This report has been prepared in response to NUREG-0737 item 1.D.1 and details the means by which a Detailed Control Room Design Review was conducted for the Turkey Point Units 3 & 4 Nuclear Power Plants owned and operated by the Florida Power & Light Company. The review was conducted using NUREGs-0700 and -0801, and spanned the period from July 1981 to July 1983.

**FIGURE 2.3.9-1  
LOCATION OF ANNUNCIATOR CONTROL STATIONS**

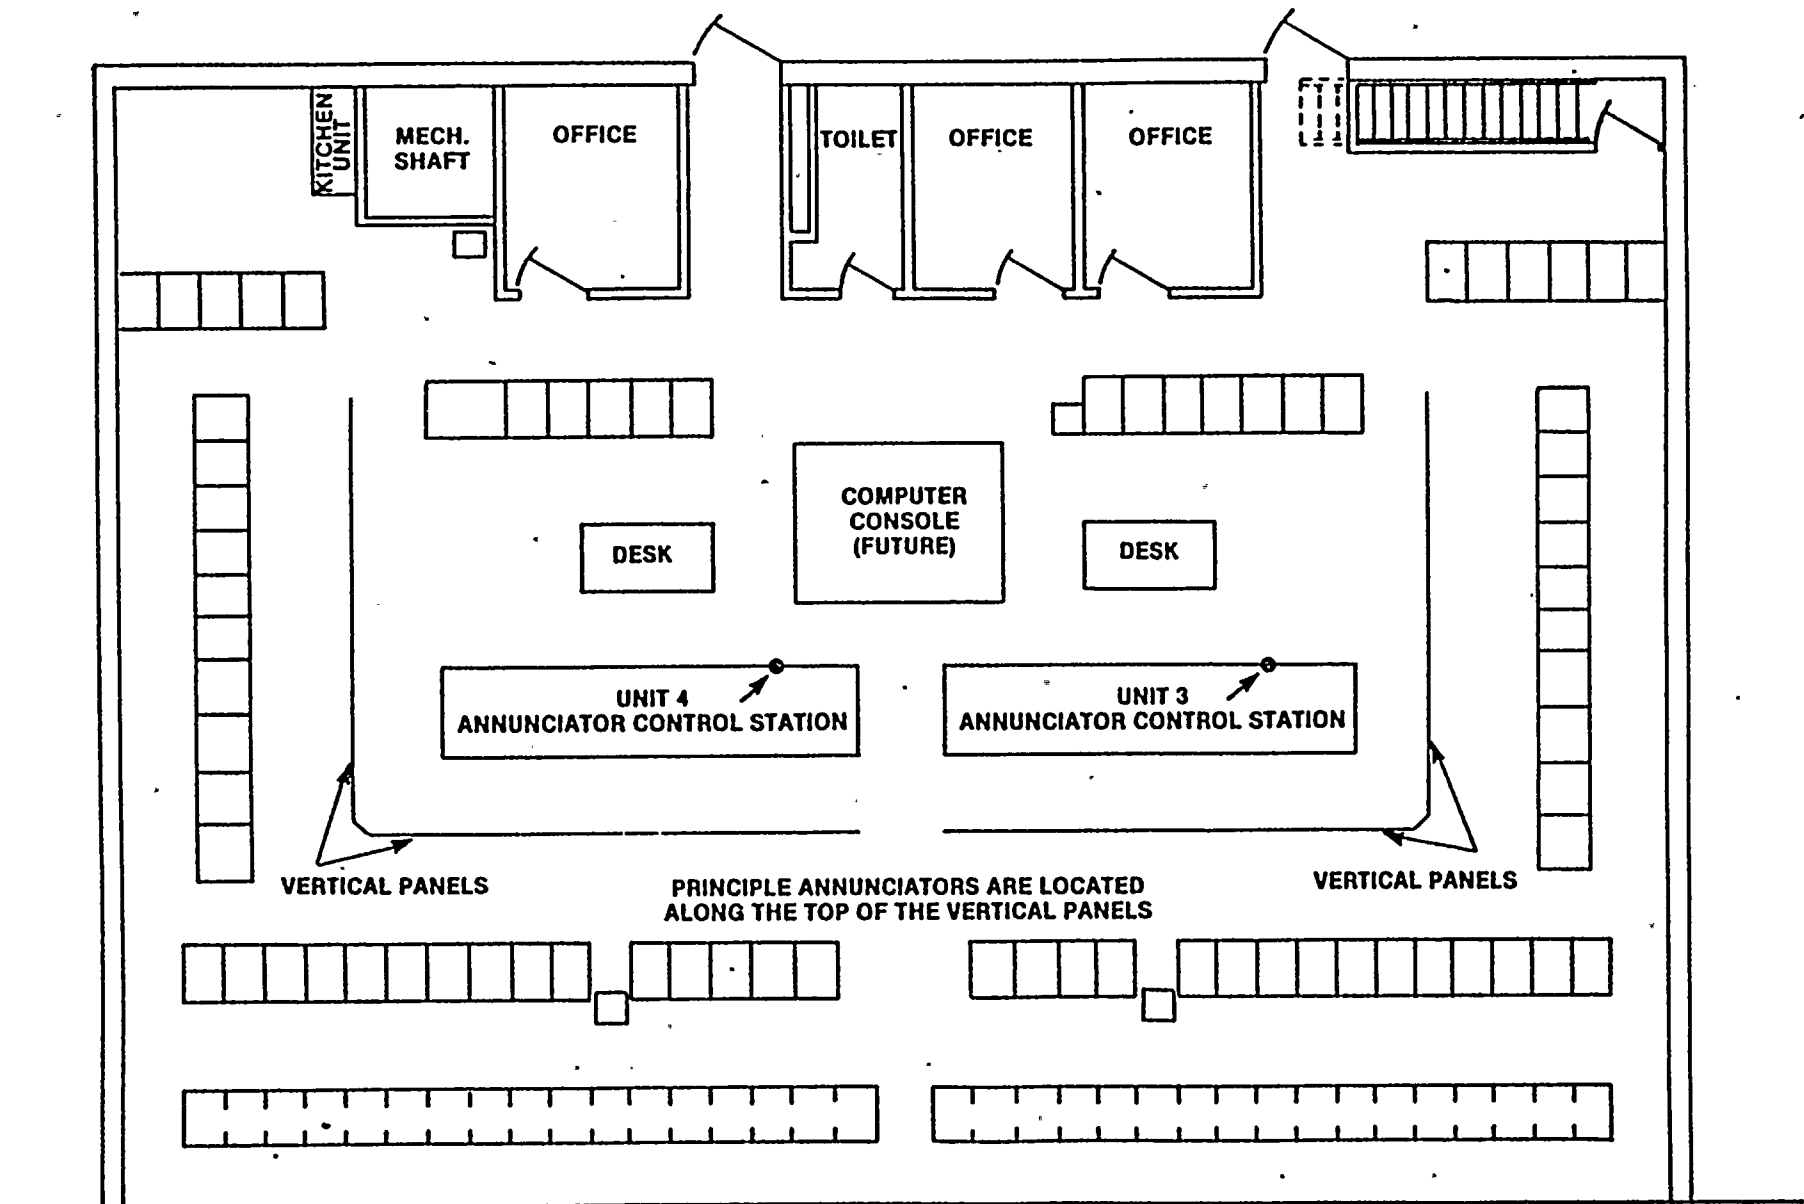
**Annunciator Controls** — Only one set of annunciator controls exists in each control room, and no test or reset functions/controls are provided. Figure 2.3.9-1 shows the location of annunciator controls for each unit. Certain advantages exist for the Turkey Point control rooms having one annunciator control station for each plant. The orienting responses to alarm control stations will be stronger (since only one response station exists), which should tend to reduce response latency. Also given the size and arrangement of the control rooms and the central location of the annunciator response stations, operator responses to anomalies could be facilitated. Several disadvantages also exist, including potential for increased control room traffic, for increased visual distances to annunciator tiles, and for possible crowding of the annunciator control locations during periods of high activity. The distance from the annunciator control location to the

individual windows, and therefore window readability, is of the most concern. Additional control stations would relieve this discrepancy, as would larger, more legible tiles.
